**TECHNICAL  
UPDATE  
March 2021**

**TU diaphragm**

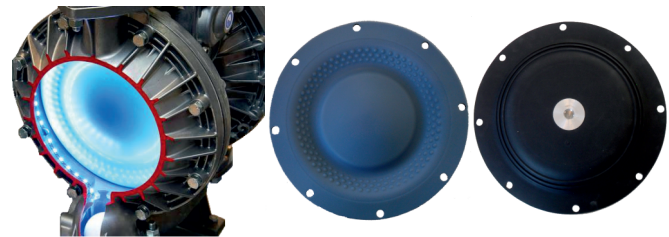
With this we like to inform you that Yamada Europe will stop immediately with the production for pumps size 80 with the so named "T-A" diaphragm. Diaphragm support these old models is possible until we run out of stock. A PTFE diaphragm with a glued conductive hytrel backing, to meet the old ATEX conformity for these size pumps.

We can no longer guarantee the supply from our supplier and the quality of these diaphragms. To compensate this lost, we have these days the TU diaphragms. A high quality diaphragm who meets a life time comparable with others like Garlock®/Gore®.

For the NDP-80 pumps fitted with T-A diaphragms, but also for other standard PTFE fitted pumps we offer a convert kit with TU diaphragms. For pumps size 80 metal we offer the **K80D-TU1**

**Convert kit NDP-80BA./BF./BS. to TU K80D-TU1**

No.	Description	Article	q'ty
7	CENTER ROD TU	717131	1
10	DIAPHRAGM TU	833231	2
40	O-RING PTFE	643078	4

**Convert kit NDP-80BP. to TU K80D-PTU1**

No.	Description	Article	q'ty
7	CENTER ROD TU	717131	1
10	DIAPHRAGM TU	833231	2
40	O-RING PTFE	643080	4

When you decide to upgrade your existing field pump, please inform Yamada Europe which pump it is, + serial number, and order a new serial number plate together with the convert kit. In this way you will keep a legal product with correct type plate information.
